Title - Sujet Air Handler/Manifold Replacement	
Solicitation No. - N° de l'invitation 39903-180402/A	Amendment No. - N° modif. 007
Client Reference No. - N° de référence du client 39903-180402	Date 2017-10-13
GETS Reference No. - N° de référence de SEAG PW-\$PWY-025-8166	
File No. - N° de dossier PWY-7-40174 (025)	CCC No./N° CCC - FMS No./N° VME
Solicitation Closes - L'invitation prend fin at - à 02:00 PM on - le 2017-10-24	
Time Zone Fuseau horaire Pacific Daylight Saving Time PDT	
F.O.B. - F.A.B. Plant-Usine: <input type="checkbox"/> Destination: <input checked="" type="checkbox"/> Other-Autre: <input type="checkbox"/>	
Address Enquiries to: - Adresser toutes questions à: Fung, Donna(PWY)	Buyer Id - Id de l'acheteur pwy025
Telephone No. - N° de téléphone (604) 671-9689 ()	FAX No. - N° de FAX (604) 775-6633
Destination - of Goods, Services, and Construction: Destination - des biens, services et construction: CFIA - Burnaby Lab - Burnaby, BC

The Solicitation Amendment 007 is raised to issue Addendum 005.

This Addendum forms part of the Contract Documents and is to be read, interpreted and co-coordinated with all other parts. Include cost of all work contained herein in the Contra

SHORT ABSORPTION MANIFOLD DISTRIBUTION PIPING
N.T.S.

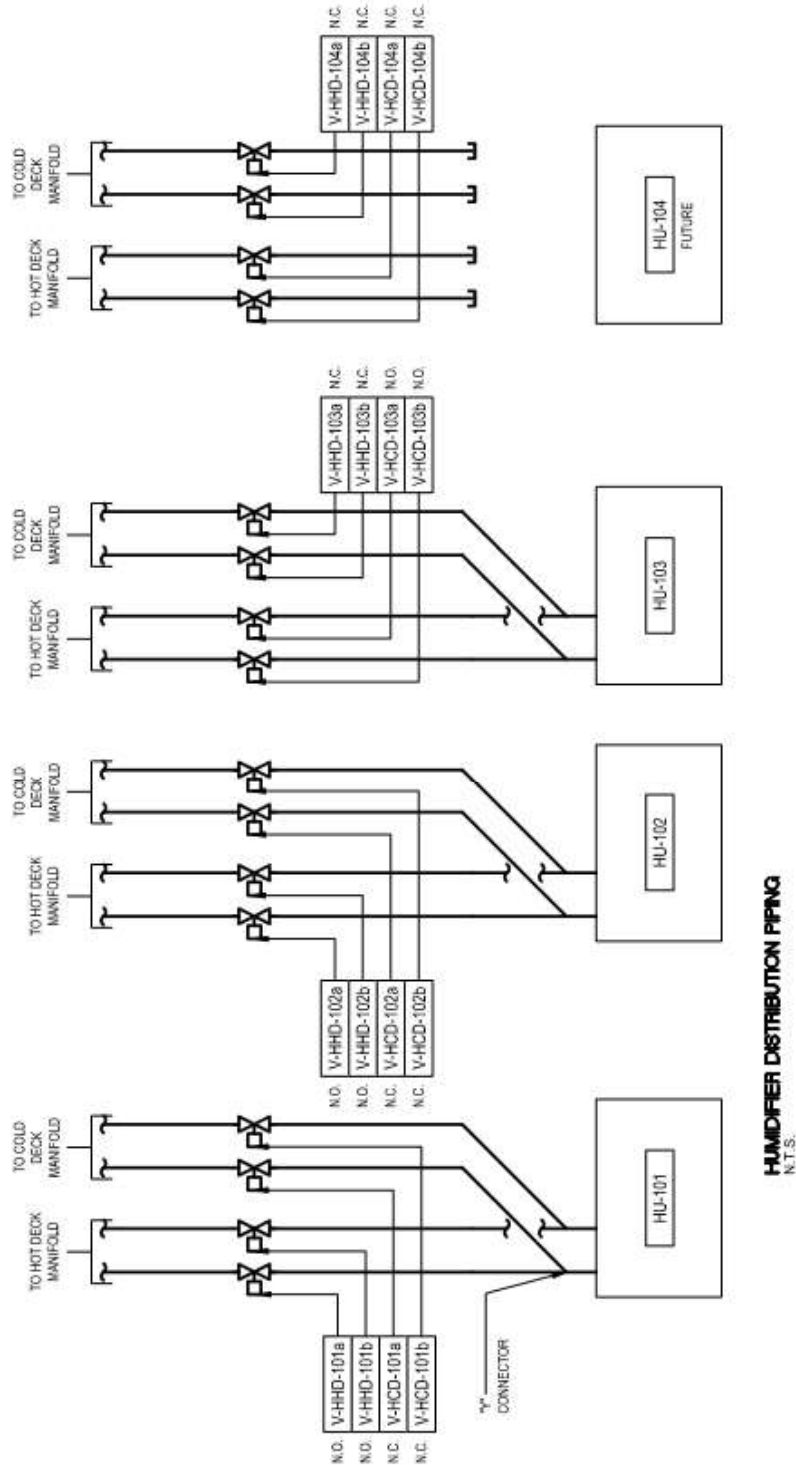
- 1. HU-104 IS TO BE PROVIDED PER SCOPE OF FUTURE PROJECT. PROVISION OF HU-104 IS NOT IN THIS CONTRACT. VALVES AND ASSOCIATED PIPING FOR HU-104 IS TO BE PROVIDED UNDER THIS CONTRACT. CAP PIPES AS NOTED.
 - 2. ALL VALVES TO BE 2-WAY MODULATING. REFER TO SCHEMATIC FOR TYPICAL POSITION.
- ALL STEAM AND DRAIN PIPING SHALL BE GROUNDED. CONDENSATE PUMPING SYSTEM SHALL BE RATED FOR 100 °C WATER.
- HHH - HUMIDIFICATION HOT DUCT
HCD - HUMIDIFICATION COLD DUCT
